EDGE-ON-HUDSON

APPLICATION FOR SITE PLAN & SUBDIVISION APPROVAL

PHASE ONE SUPPLEMENTAL SUBMISSION

Re: Phase 1 Site Plan and Subdivision Application
Edge-On-Hudson Riverfront Development
199 Beekman Avenue, Sleepy Hollow

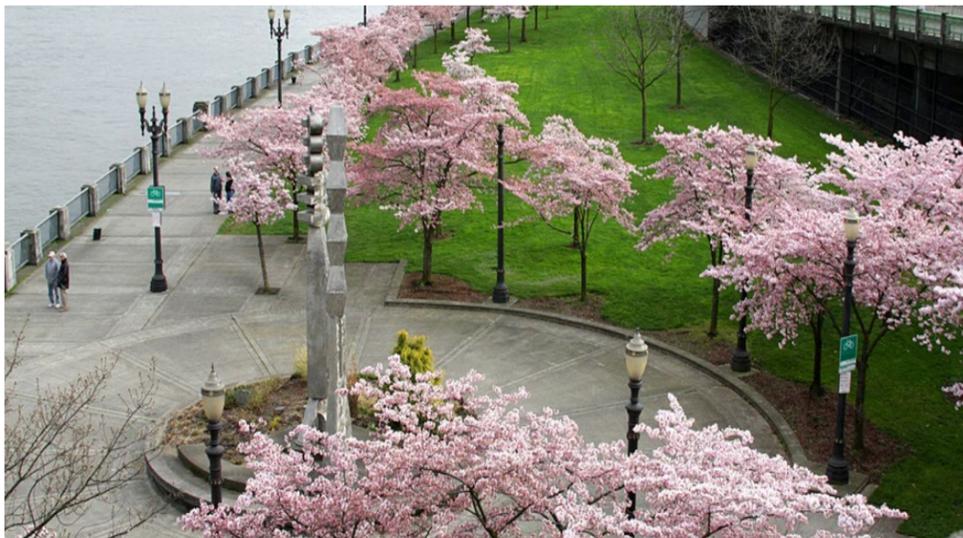
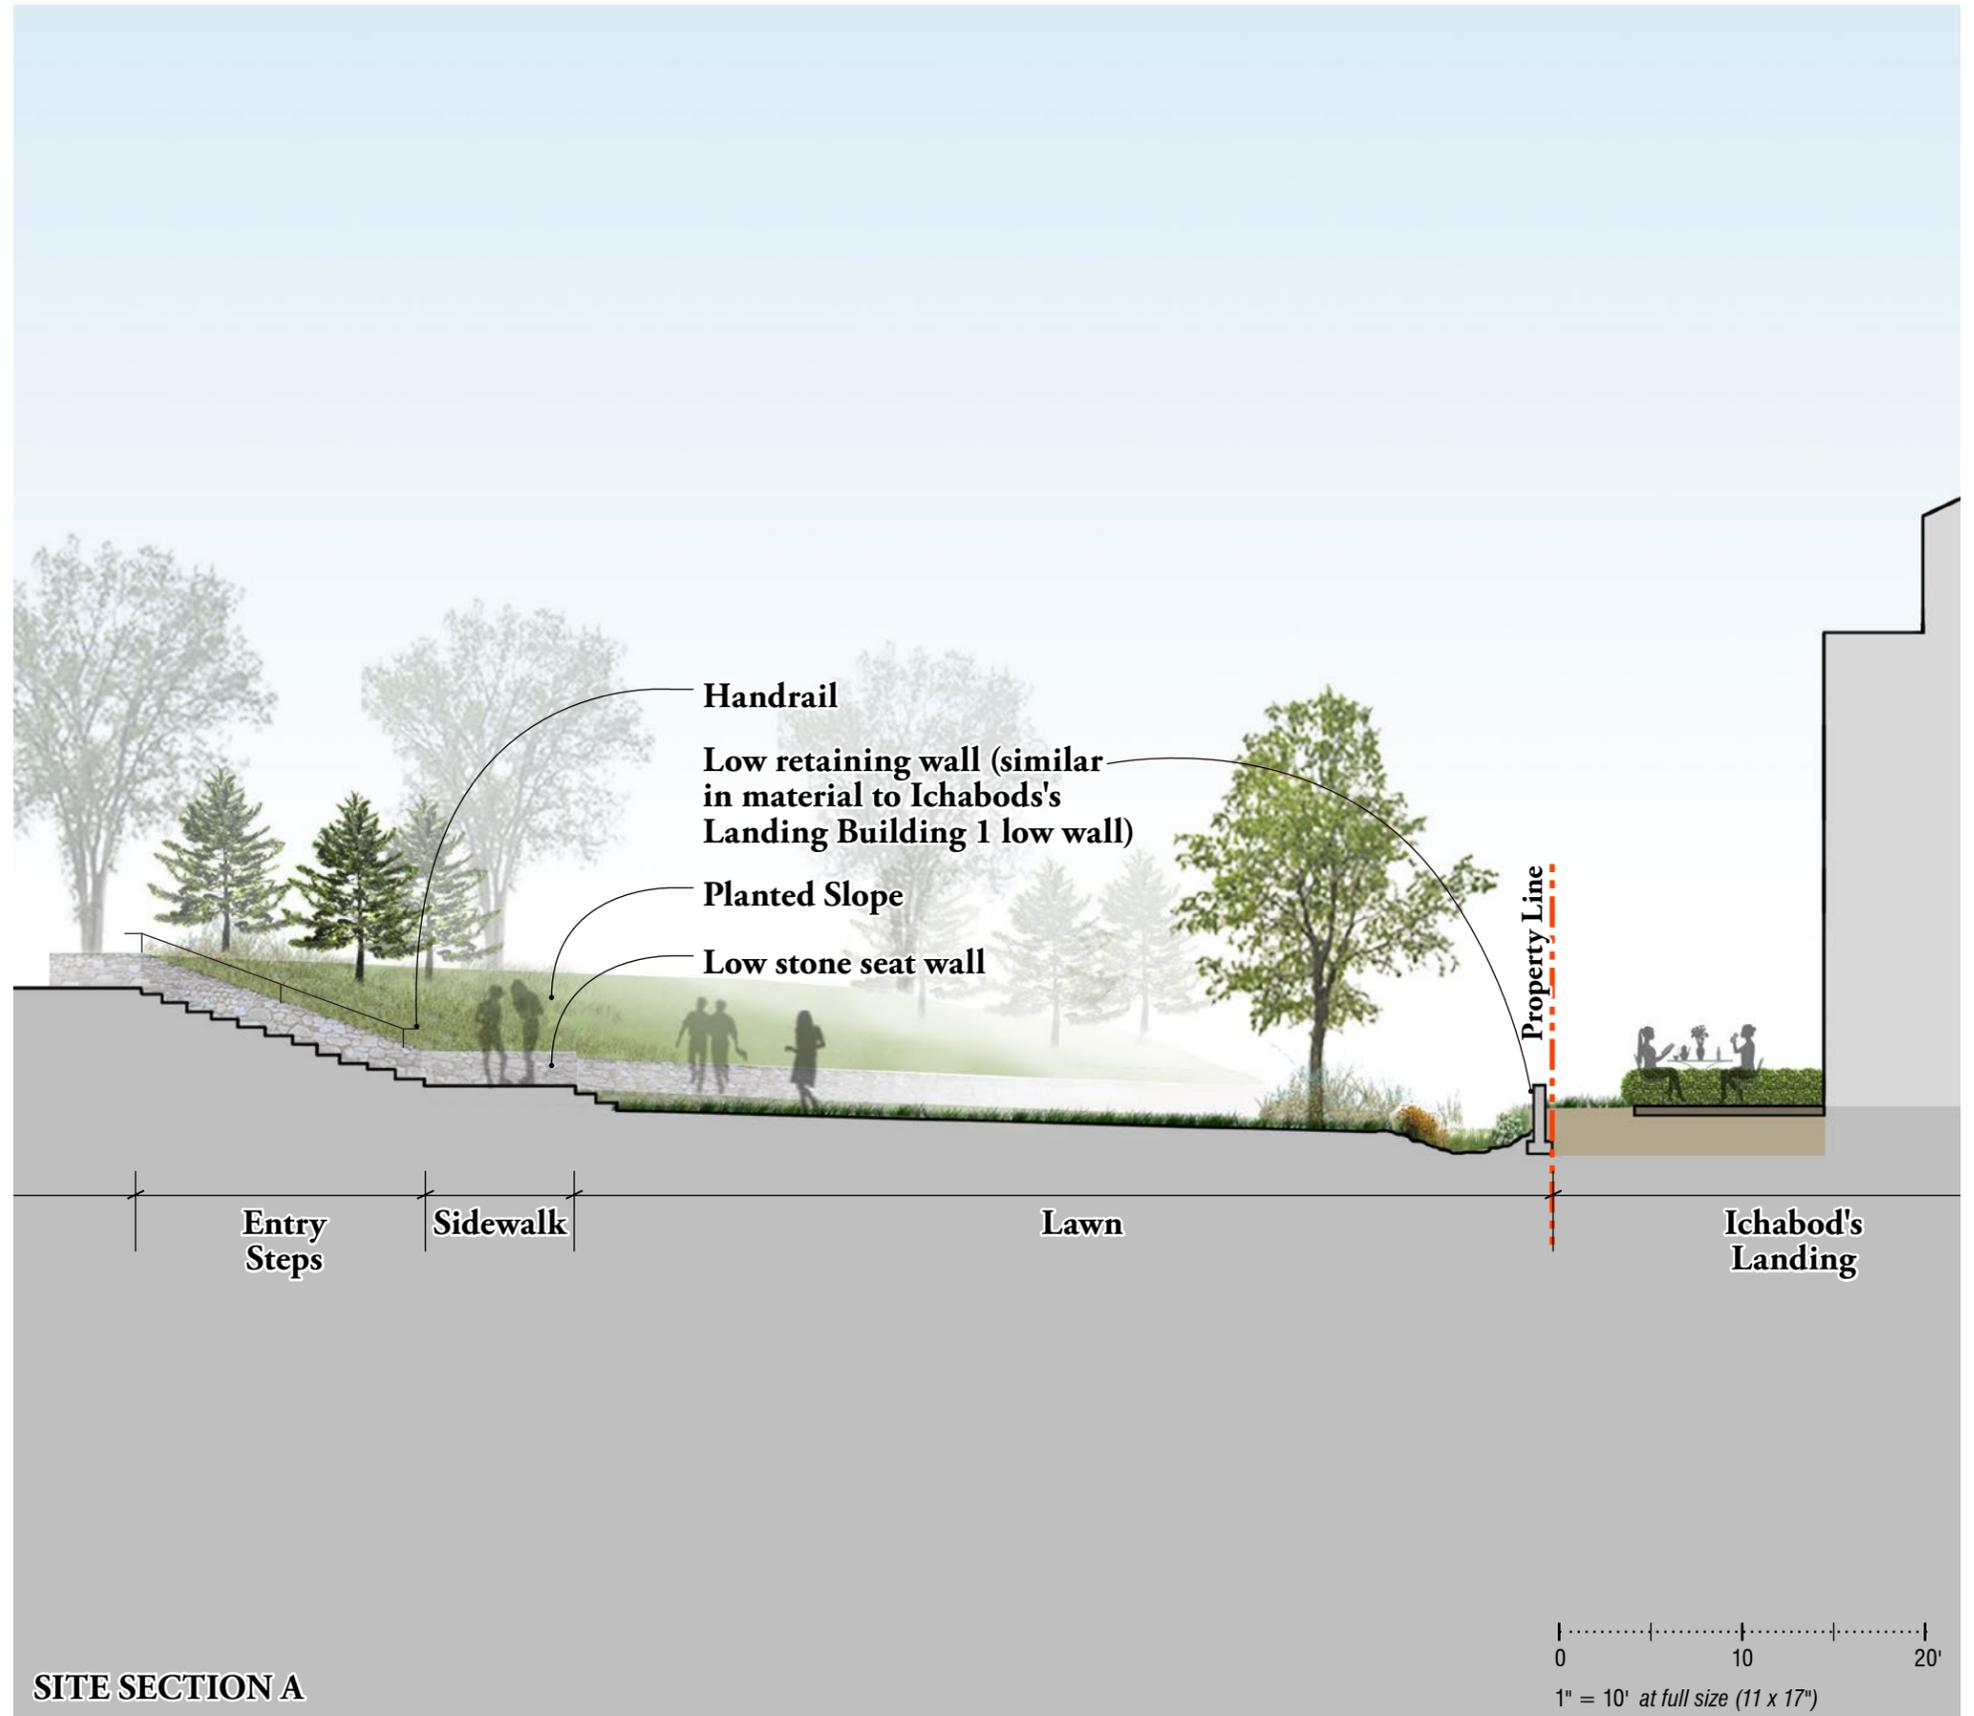
- Response:** Comment noted.
14. **Comment:** *The interface between the Edge on Hudson project and Ichabod's Landing is a critical design consideration. It would be important for the Applicant to provide details as to the materials being considered for the new permanent staircase, low garden wall, temporary overlook and walkway to the waterfront.*

- Response:** The Applicant has been working in coordination with the adjacent property owners at Ichabod's Landing to further develop the design of the Village Green, as shown on pages 10 through 12 of the Landscape Architecture Exhibit. The plans include an eight foot-wide curvilinear

walkway, framed by a low stone seat wall that leads down to a Waterfront Plaza and provides a scenic overlook of the Hudson River. A planted slope and a lawn area are intended to frame the sidewalk. Native grasses will be planted as well. To add texture a decomposed granite area for gathering is proposed. Also highlighted on the plan is an emergency access route between the two developments that will be covered with grass pavers. Removable bollards will enhance the pedestrian friendly nature of this space, yet provide access to emergency responders when required.

Garage Plan

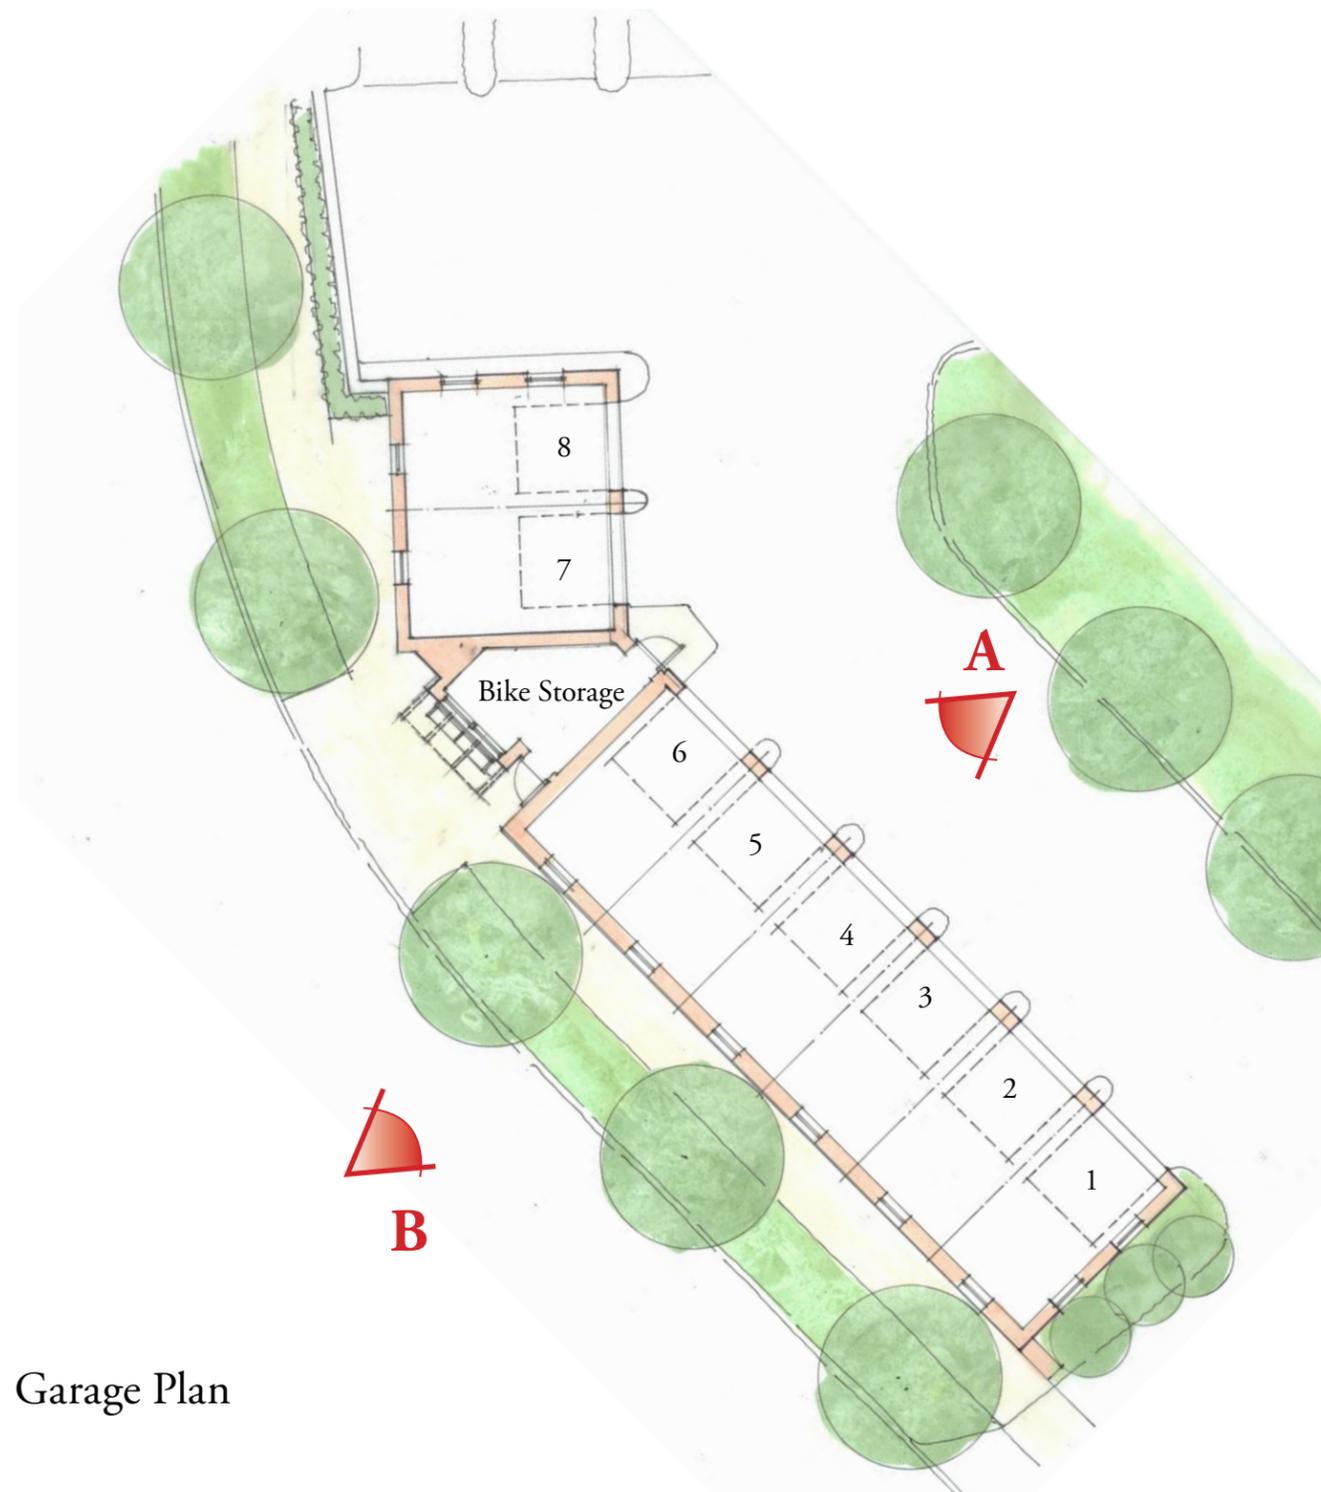
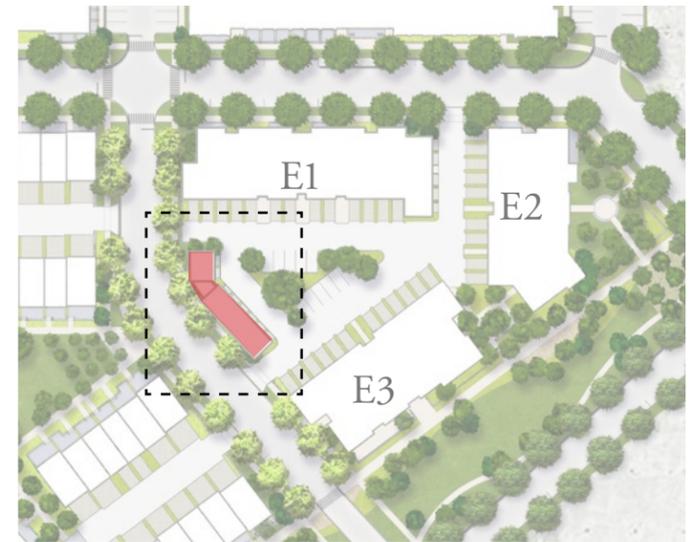
23. **Comment:** *The Block E layout includes two small out buildings which will be used for parking. The Applicant needs to provide details as to the design of these buildings. The visual aspect is important given that these buildings front on Road Three.*

- Response:** Plans and elevations for the detached garage buildings in Block E are provided on pages 13 and 14 of the Architecture Exhibit. The facades of the garages incorporate design elements and materials utilized in the design of the condominiums within Block E.
